Bid Bulletin #02

PROJECT: Baldwin Filters Distribution Facility (Bid Package #02)
Kearney, NE

ADDENDUM

PROJECT: Baldwin Filters
Main Distribution Center
Bid Package #2 - Electrical
Kearney, Nebraska

In reference to Sheet E-601, on the Electrical Riser Diagram, add the following:

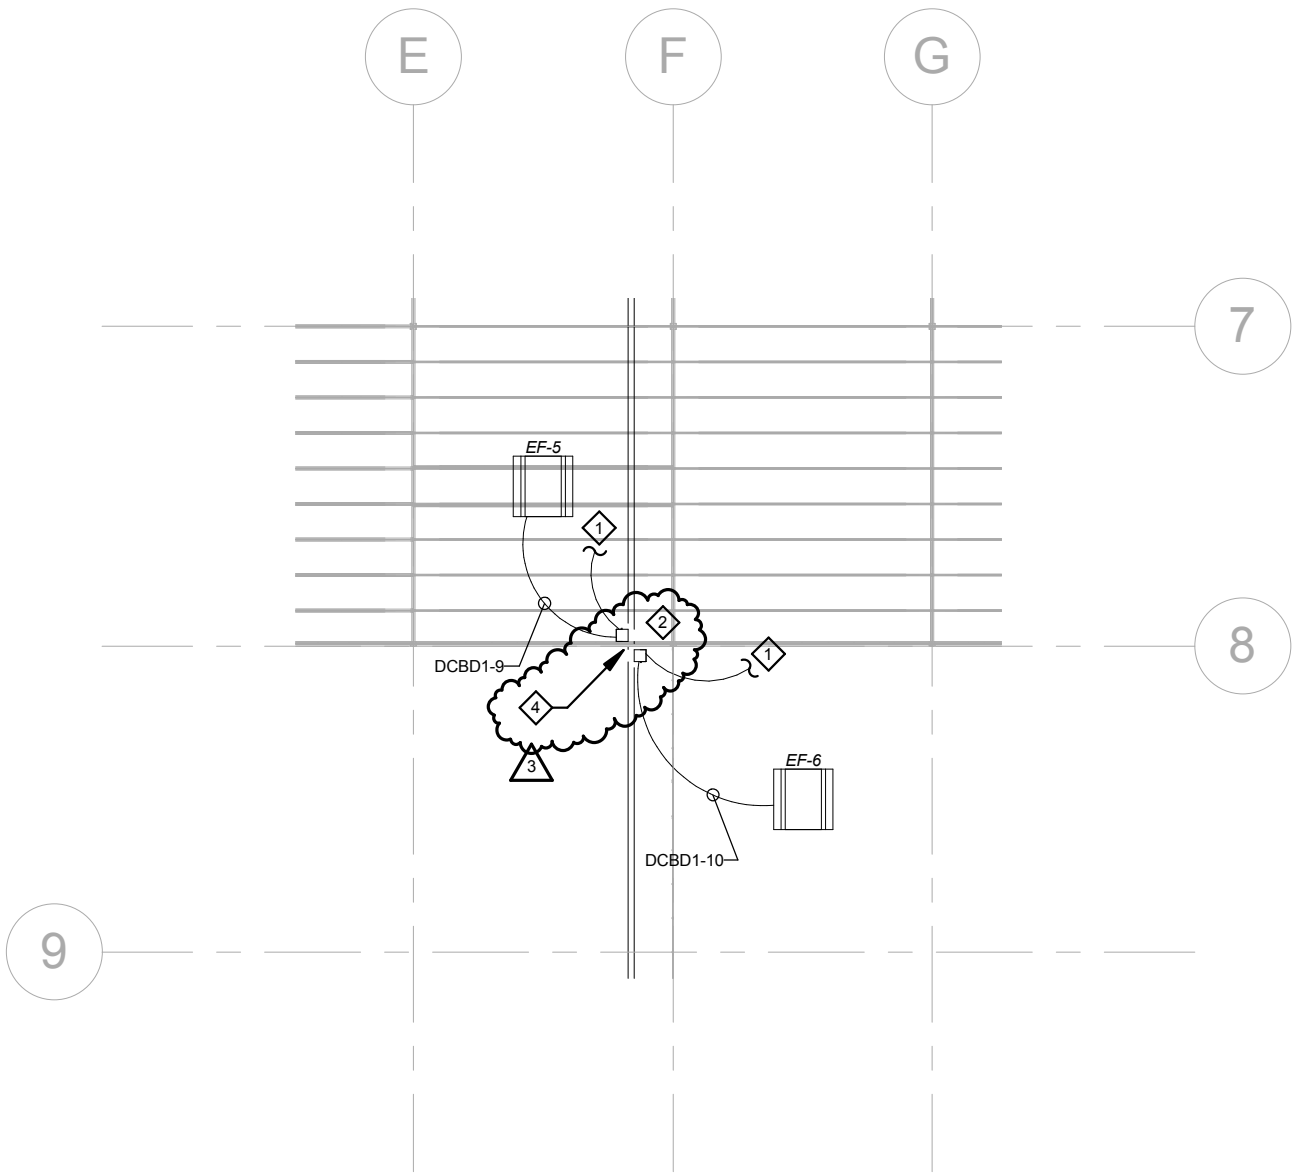
Feeder from the generator to panel EMDP shall have a feeder tag of 4.
Feeder from MSB-DC to Overhead bus duct feeder tag shall be deleted.
Feeder from MSB-DC to ATS LS shall have feeder tag changed from 9 to A.
Feeder from Panel EMDP to ATS LS shall have feeder tag changed from 9 to A.
Feeder from MSB-DC to ATS EQ shall have feeder tag changed from 4 to A.
Feeder from Panel EMDP to ATS EQ shall have feeder tag changed from 4 to A.
Feeder from Panel H3A to H3B shall have a feeder tag of 8.
Feeder from Panel HLS3 to XFMR TLS4 shall have the feeder tag changed from 11 to 13.
Feeder from XFMR TLS4 to Panel LLS4 shall have the feeder tag changed from 13 to 11.
Feeder from Panel HLS6 to XFMR TLS6 shall have the feeder tag changed from 11 to 13.
Feeder from XFMR TLS6 to Panel LLS6 shall have the feeder tag changed from 13 to 11.
Feeder from Panel L10A to Panel L10B shall have a feeder tag of 8.

On the feeder schedule, for Tag 2, change ground conductor size from #2 to #3/0.
On the feeder schedule, for Tag 3, change ground conductor size from #2 to #1/0, and conduit size to 4".
On the feeder schedule, for Tag 4, change ground conductor size from #4 to #3.

Add General Note #1 to read as follows:

"1. Equipment shown as 'Future' and associated feeders shall not be included in the bid at this time.

Add Keyed Note 12 to read as follows:

"12. Generator shall have one 400 amp, 3-pole breaker and one 125 amp 3-pole breaker." And insert keyed symbol at generator on riser.
